Remedy Optimization Team Report for the Bethpage Groundwater Plume Remedy

The Technical Team for Optimization of the Bethpage Plume Remedy

Naval Facilities Engineering Command Mid-Atlantic

June 15, 2011

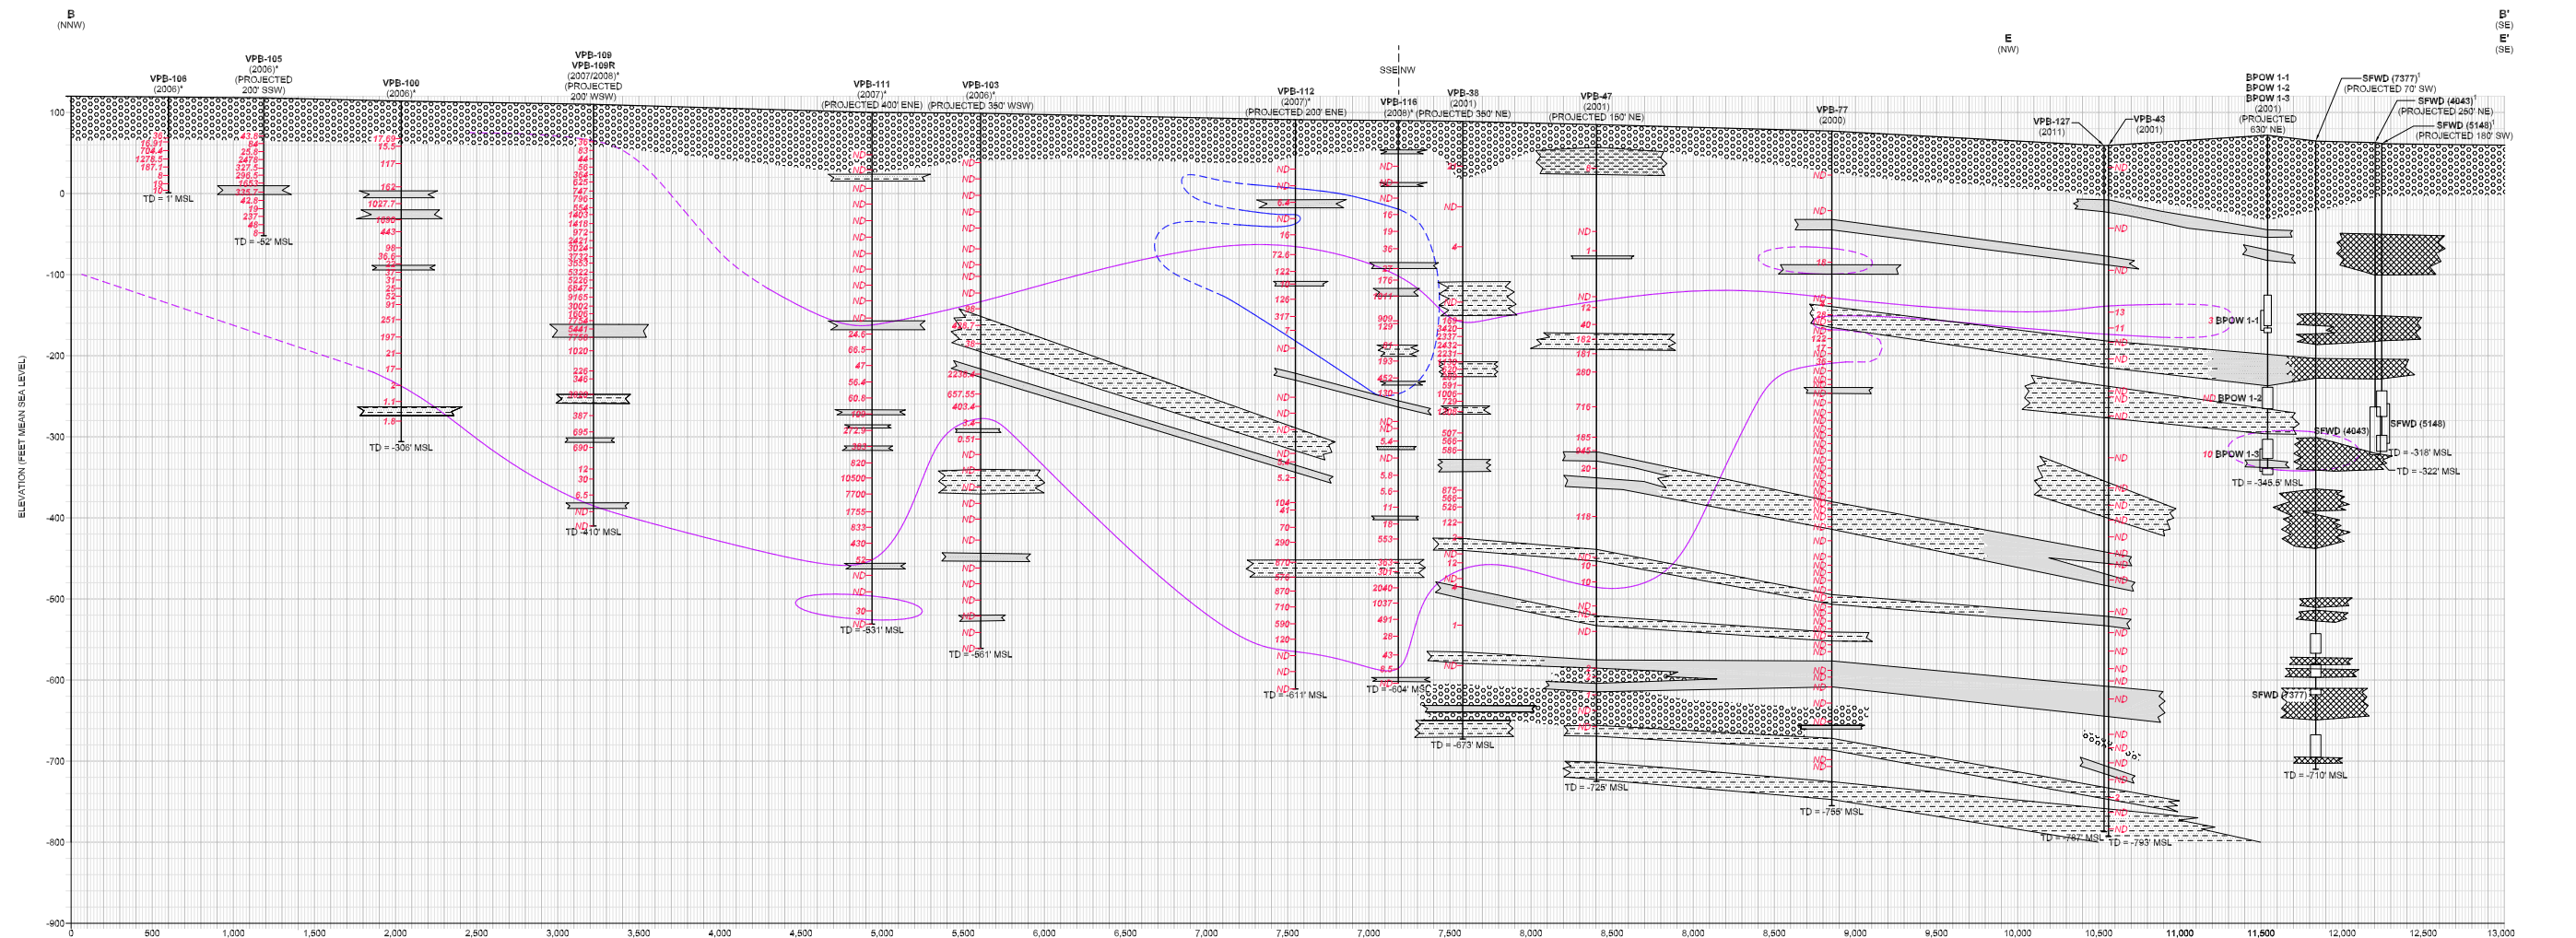
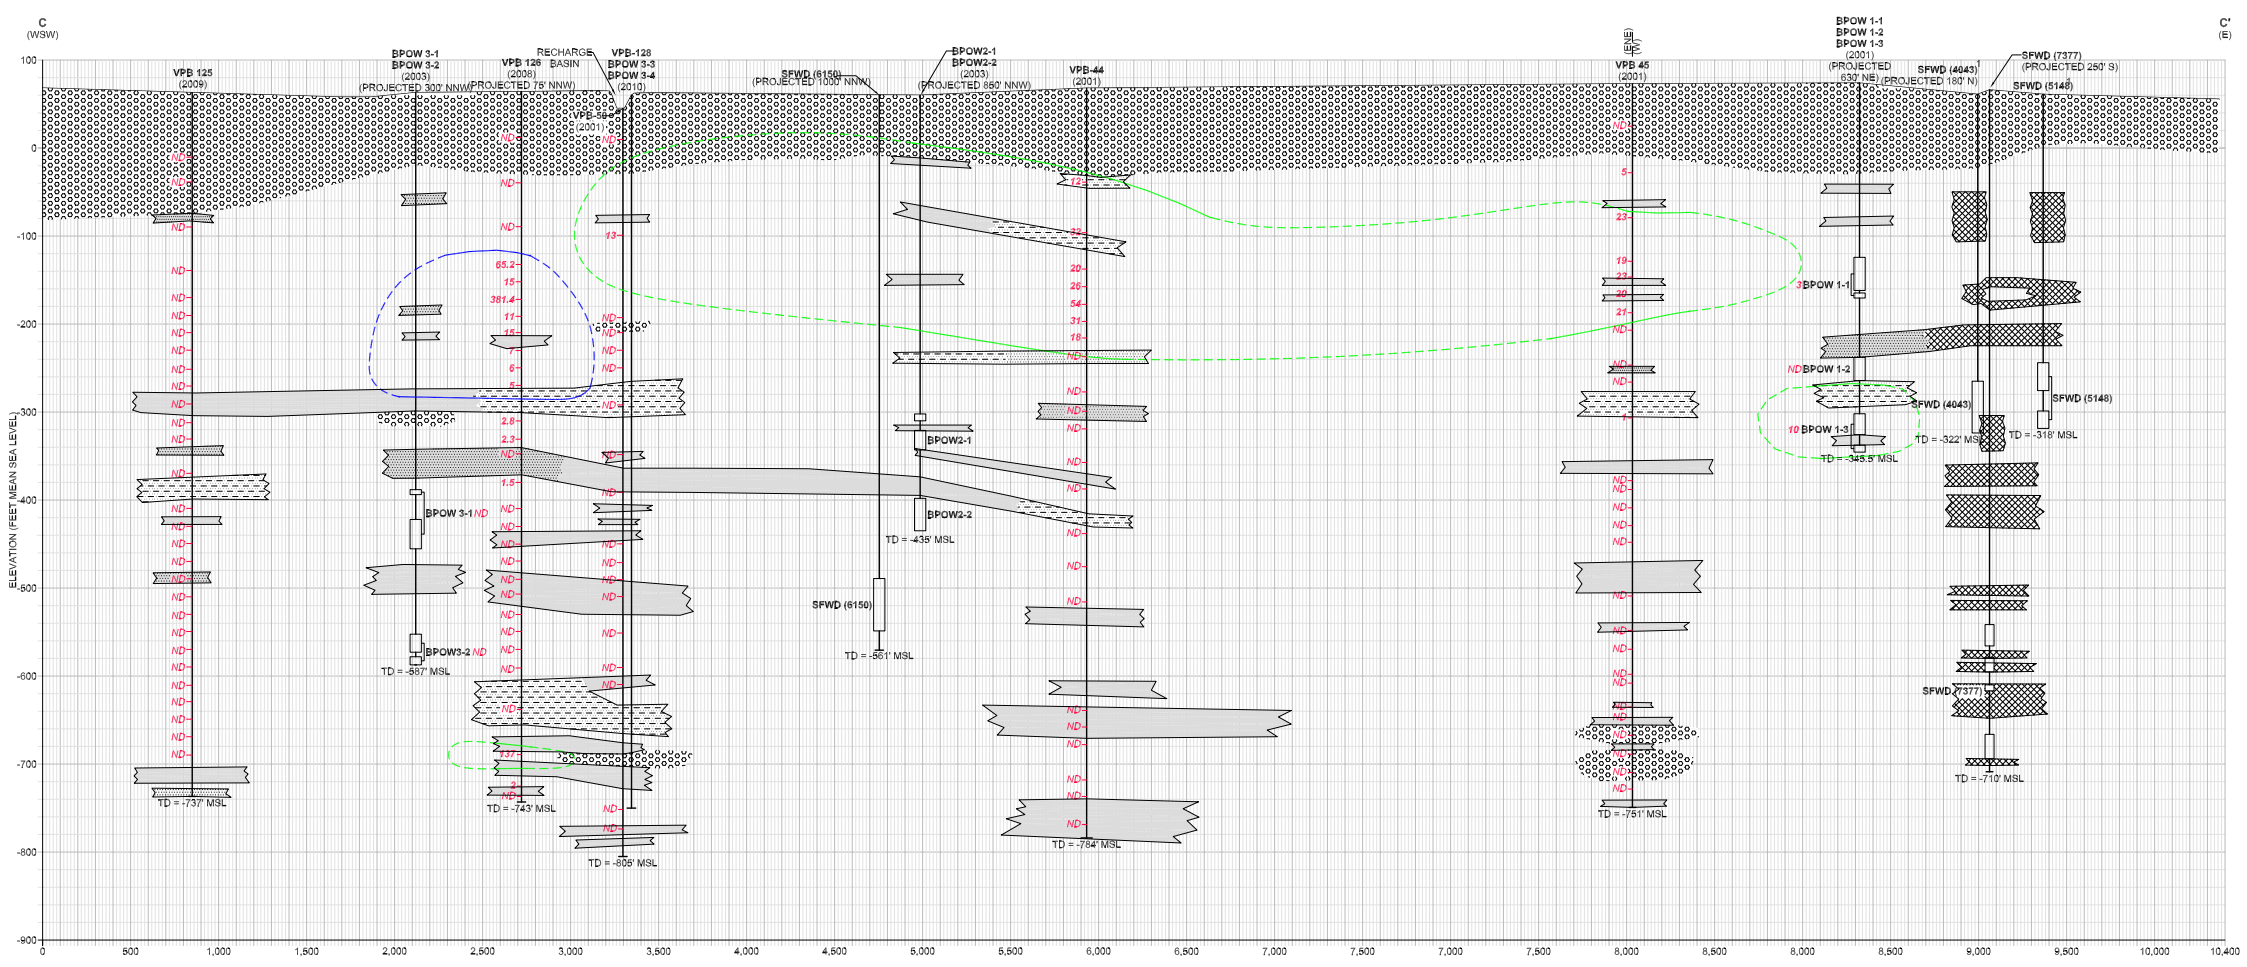
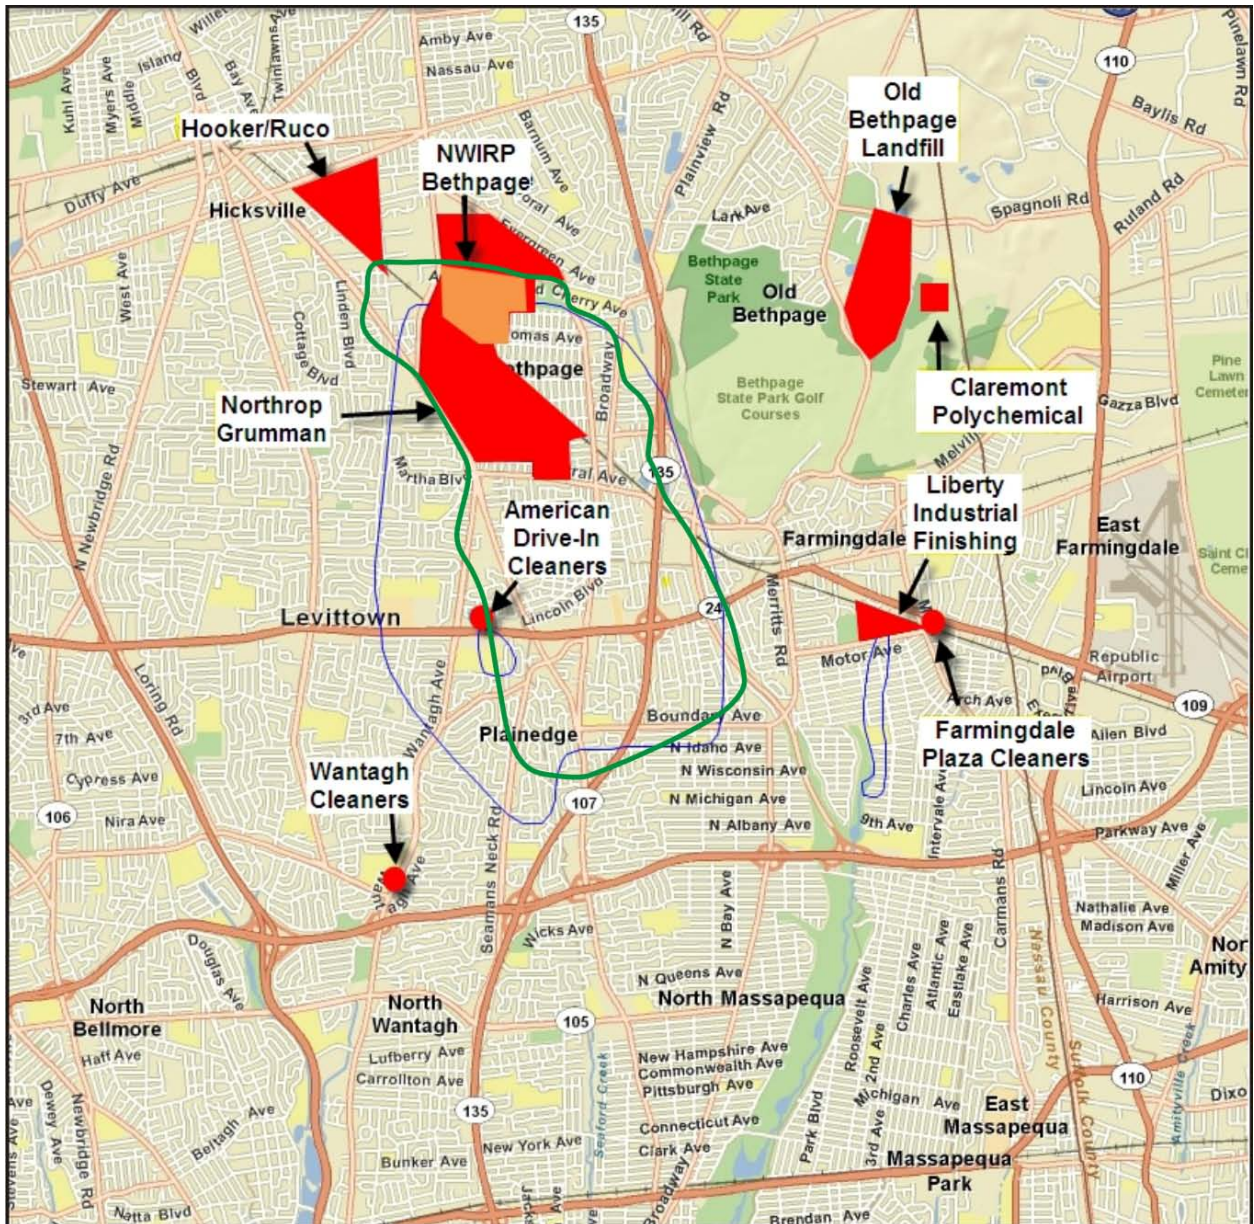
15	<p>6: Lithological Cross Sections (Appendix B)</p>	<p>Comment noted. The Technical Team agrees that limited spatial data are leading to uncertain interpretations of geologic units. This has been and will continue to be one</p>

Comment Number	Comments	Response
	<p>A number of the interpretations of low-permeability units appear to be inaccurate and not consistent with the depositional environment of the Magothy formation or the findings of the USGS and others that zones of low permeability are, for the most part, laterally discontinuous. For example: 1) some low permeability units show no dip; 2) other units show a steep dip; 3) other units arch upward; 4) various lithologic descriptions are correlated as one continuous low- permeability unit; and 5) relatively thin units are interpreted to be continuous over considerable distances. Also, the cross sections present an overly-simplified plume depiction. More detailed contouring of VOC concentrations may lead to a better understanding of plume stratification and potential sources, especially on Section B-B'. The Study Area RI Report provides a detailed analysis of VOC concentrations along a line of section similar to Section B-B' (Figure 5). Also, as stated in the Navy Work Plans, the objective of drilling to depth and mapping the upper surface of the Raritan Confining unit does not appear to have been achieved.</p>	<p>of the inherent limitations in understanding and/or modeling the groundwater flow and VOC transport at this large and complex site.</p> <p>The following additional information was provided by Tetra-Tech, the Navy contractor:</p> <p>“We acknowledge the general theory on the depositional history of soils on Long Island, as well as the general basis for the formation of low permeability units. This general theory provides a good starting point for understanding groundwater flow in the area. However, based on site-specific information, many localized variations in the general theory have been identified. In particular, based on very detailed work done on Navy property, clay units have been identified as flat (especially when viewed along the strike), steep, or even upward. The low-permeability units presented on the cross section are based on a very detailed evaluation of site-specific information and provide a good basis for understanding potential and actual groundwater and contaminant flow through the area. Where multiple borings show the same lithological signature, the units are shown as connected on the cross section. We recognize that this level of granularity would seriously limit the ability to accurately model groundwater and contaminant transport in the area, but present it because of the need to identify potential contaminant migration.</p> <p>The level of detail on the VOC contouring is likewise accurate based on the data available. This evaluation utilizes the location of known contamination and potential groundwater flow. In addition, where groundwater data are conflicting or variable, the mapping uses a conservative approach, especially where the presence of VOCs may vary based on time. For example, a water district supply well may pull contaminated groundwater from the east, west, or even south under a continuous, semi-confined seasonal pumping scenario. This condition was documented during the testing of GM-38 System, Recovery Well No. 2, where the pumping test was affected by the operation of BWD Plant No. 4.”</p>
